State of Alaska
Department of Environmental Conservation
Village Safe Water Program

Re: Amendment 3
ITB 23-VSW-TLT-023
Tuluksak Water Treatment Plant / Washeteria Project
ITB Due Date: July 18, 2023 @ 2:00 PM AST

Sheet No. E012

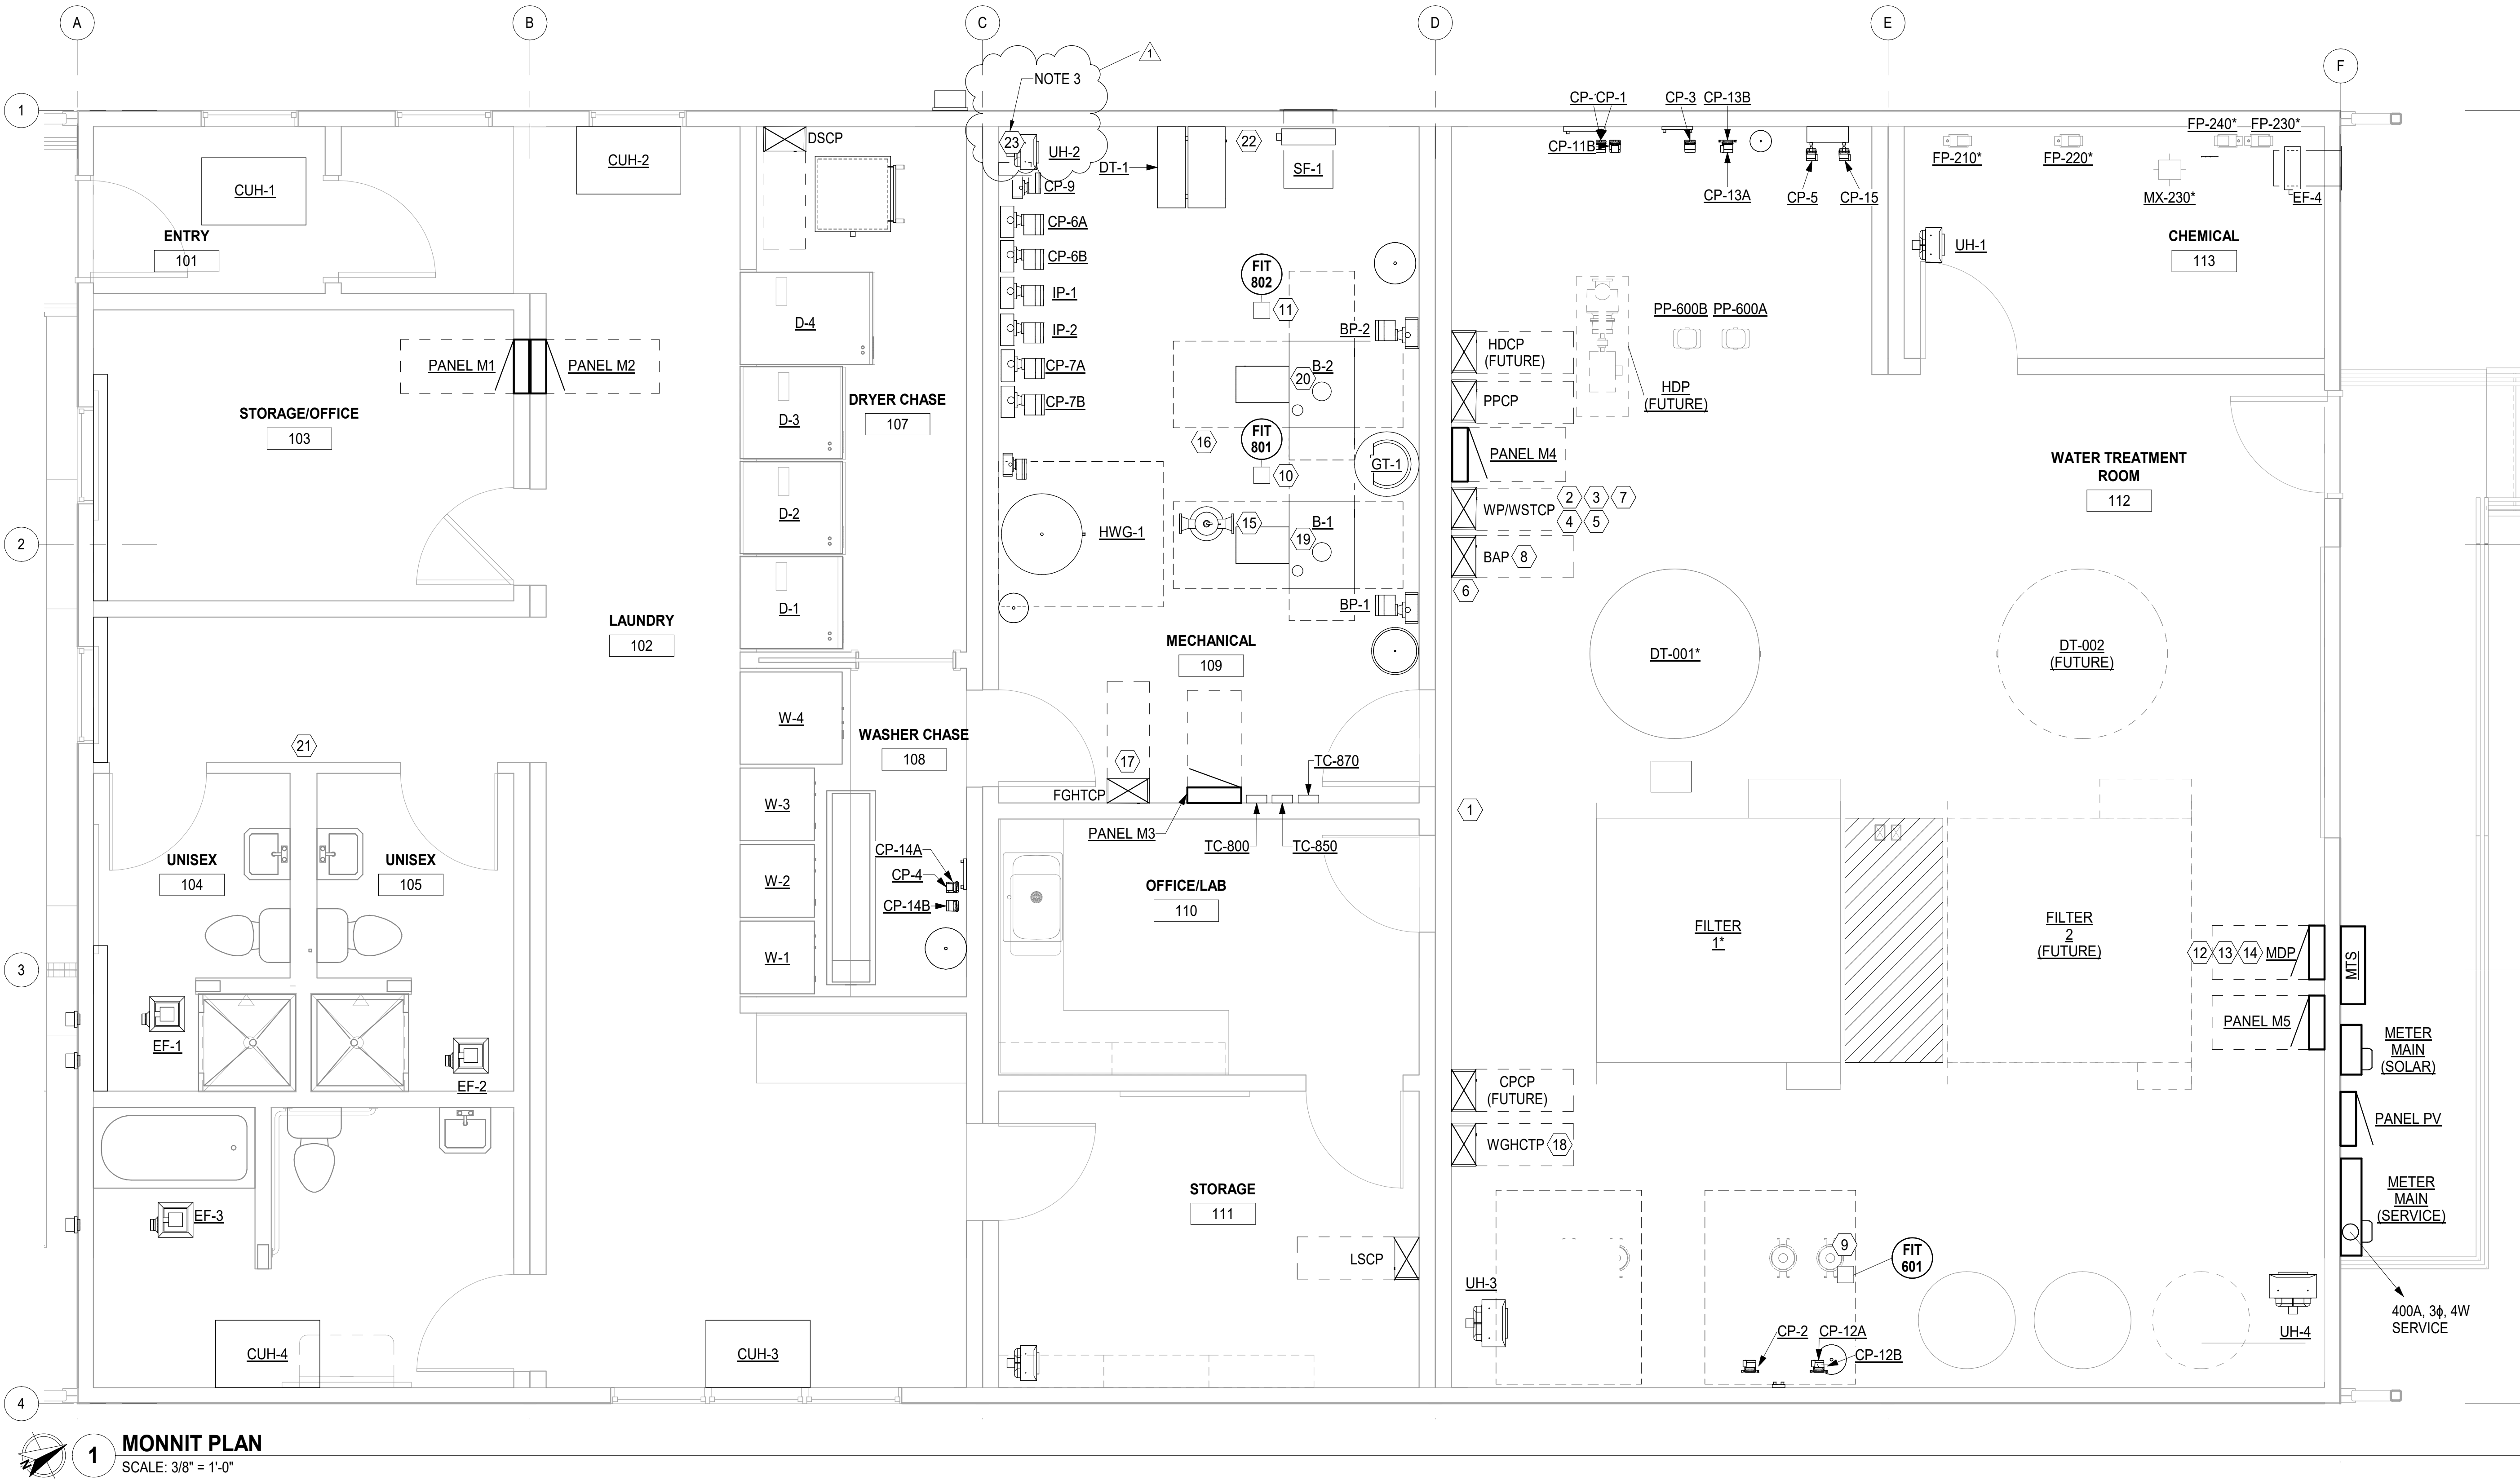
NO.	REVISION	BY	DATE
1	ADDED TEMP SENSOR TO WHRS SUPPLY	TRK	05.30.2023
2	CHANGED PART NUMBER OF ITEM 23	TRK	06.02.2023

NO.	REVISION	BY	DATE
1	ADDED TEMP SENSOR TO WHRS SUPPLY	TRK	05.30.2023
2	REVISED NOTE 3 TO ADD THERMOCOUPLE	TRK	06.02.2023

SEE SHEET E106 FOR MONNIT PLAN.
SEE MECHANICAL AND PROCESS DRAWINGS FOR INSTRUMENTATION LOCATIONS.
*PROVIDE THERMOCOUPLE WITH K-TYPE CONNECTOR IN THERMOWELL FOR BOILER SUPPLY AND RETURN TEMPERATURES.
** PROVIDE K-TYPE THERMOCOUPLE WITH QUICK CONNECT IN THERMOWELL IN WHRS SUPPLY PIPE FOR TEMPERATURE SENSOR.
